(Connection of charger to battery)

Work Instructions for assembly Ferrites

Old situation

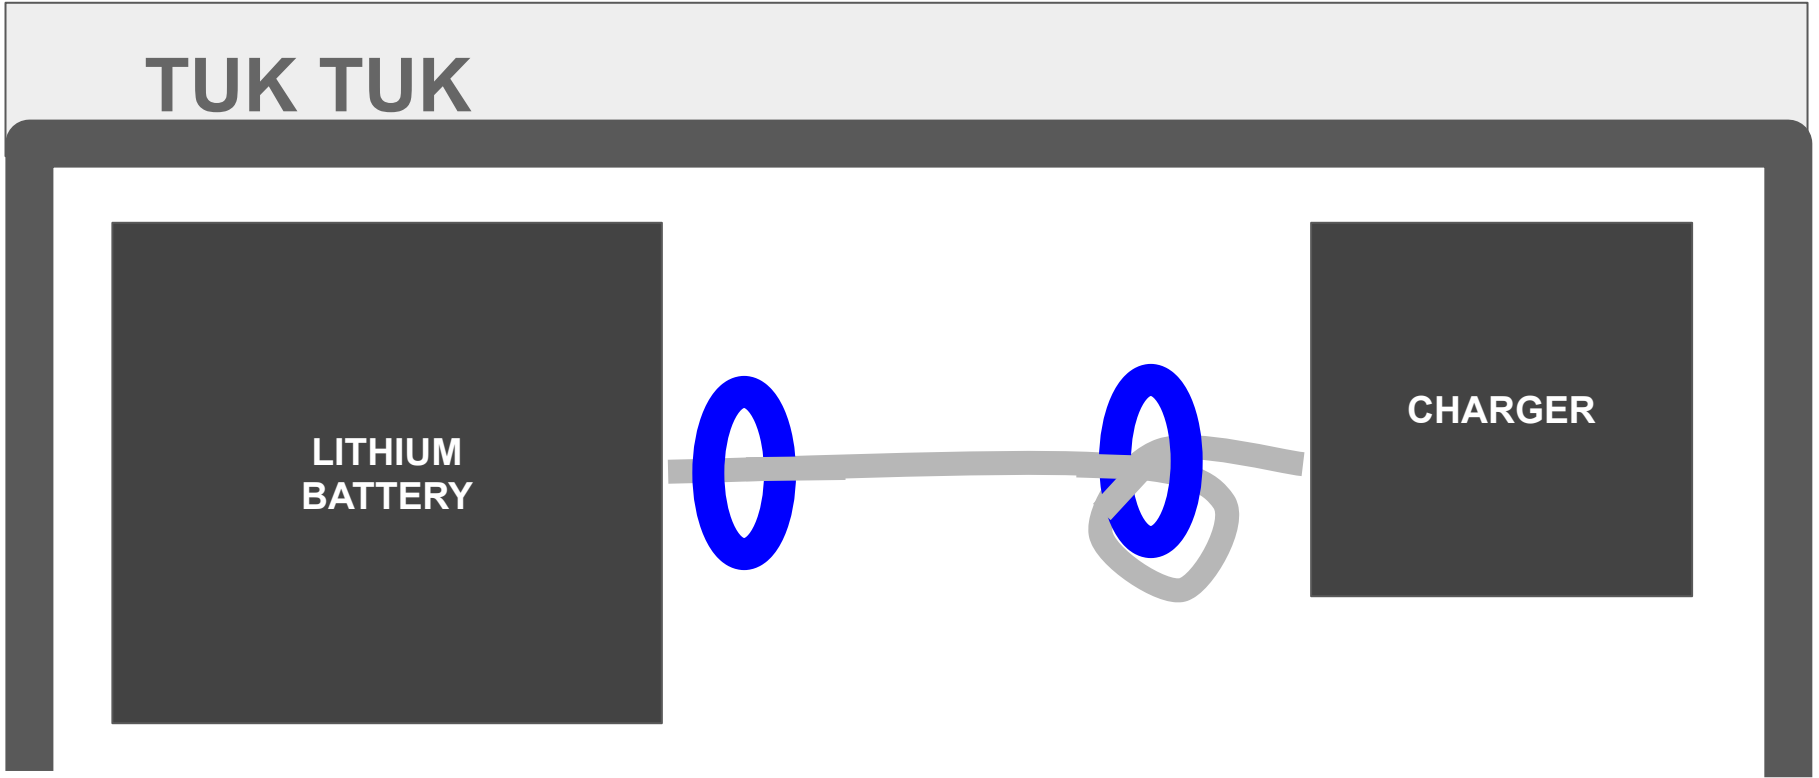
Old system with only one ferrite, placed in the middle of the output cable.

With the cable in a loop through the ferrite ring.

New Assembly with two ferrites, one placed near the charger and the other near the battery. Fix the ferrites with plastic clamps as shown in the pictures..

1. Switch off vehicle and charger
2. Disconnect the charger to battery power cable
3. Add 1 extra blue ferrite ring to the charger to battery power cable
4. Move the ferrite ring with the loop of the cable closer to the charger and fix with a tie-wrap
5. Fix the 2d ferrite ring to the battery box cables, the charge cable needs to run through the ring.
6. Connect the charge cable to the battery.
